Essential Repair Finding – FCVINE-W.5-SUMV

Structure Description: FCVINE-W.5-SUMV is concrete rigid frame with a widening comprising a concrete slab supported by concrete wall abutments.

Essential Repair Finding – FCVINE-W.5-SUMV

Special Unscheduled Draft Report

Elevation looking north

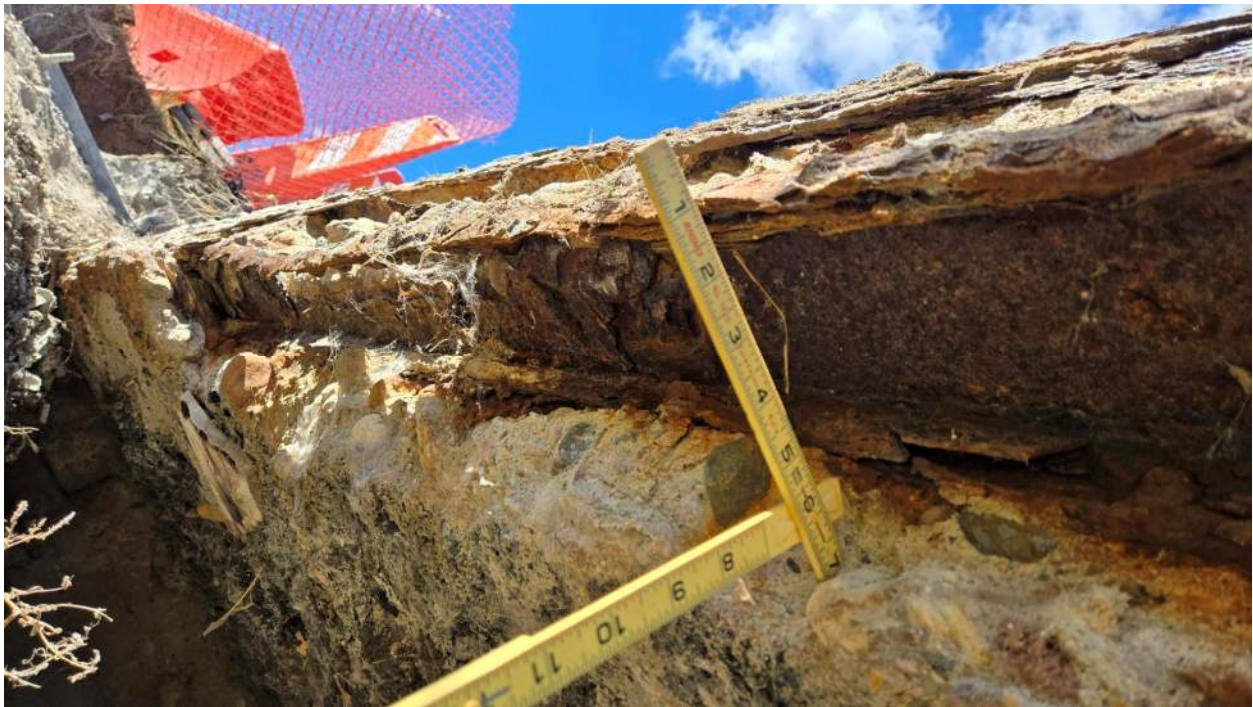
South vertical plate has failed

South member at midspan has 1.5 inches vertical sag

South member 4 feet from Abutment 1 bottom channel south flange and web have 80-100% section loss for 6 feet.

It is our office's recommendation that load posting signs be installed in accordance with the sign diagrams shown in Attachment 1 and according to the guidelines in Attachment D – CDOT Load Posting Guidelines for the Colorado Posting Trucks, Specialized Hauling Vehicles and Emergency Vehicles. Per the most recent inspection report dated 10/28/2025 and load rating dated 10/30/2025, the bridge requires posting for all vehicles. To properly post the bridge, we recommend that the following be implemented:

SINGLE LIMIT POSTING SIGN
Off-System Bridges

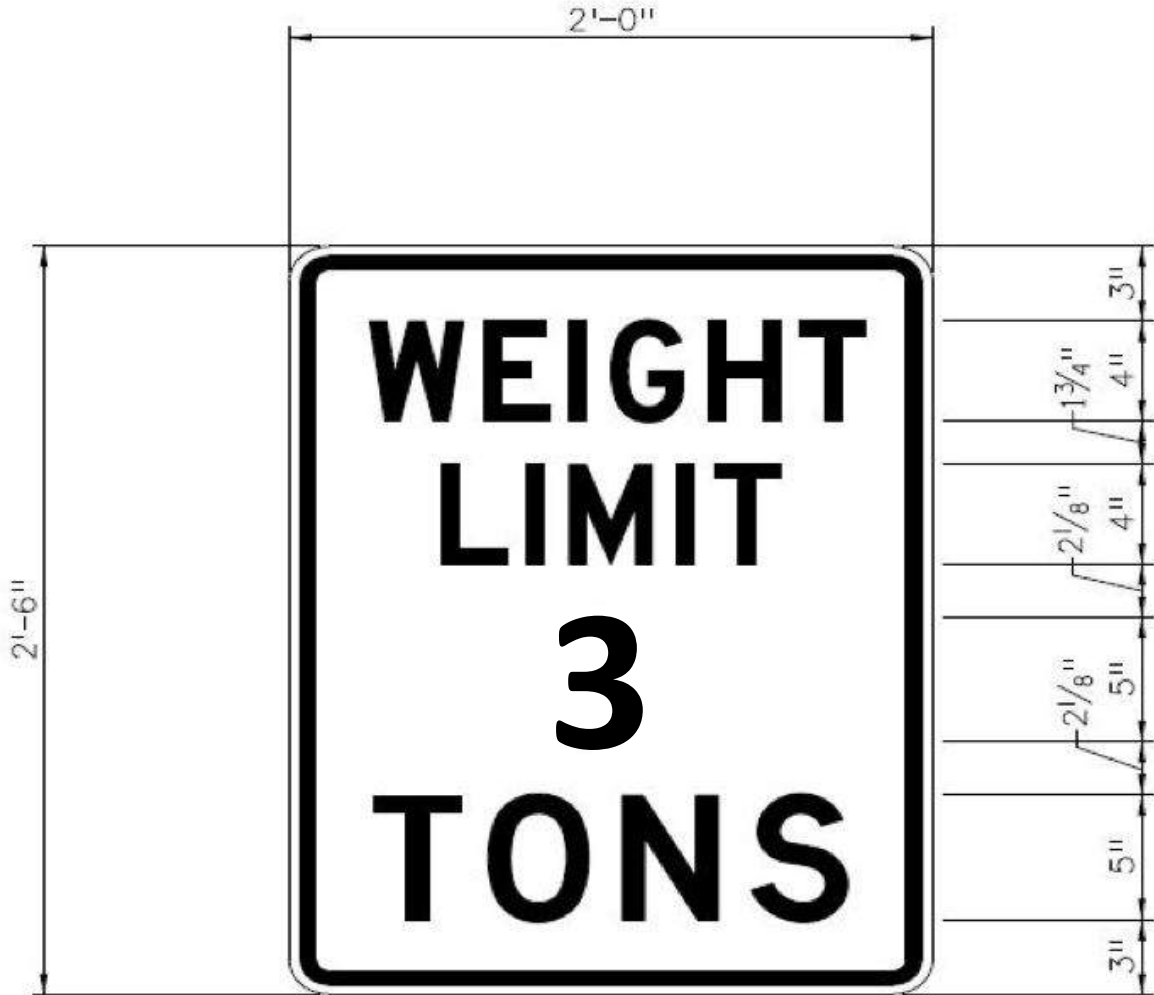
- Install a Single Limit Posting Sign (MUTCD R12-1) at the west approach to the bridge as shown in Attachment 1 (total of 1 signs).

38 - Reinforced Concrete Slab

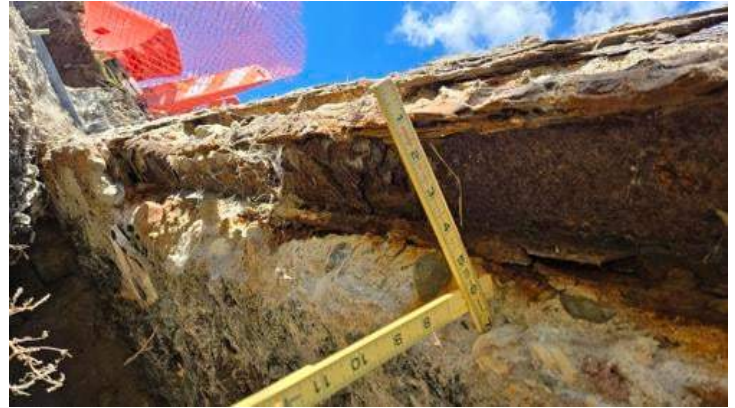
Area of exposed cross bracing shows no intermediate members
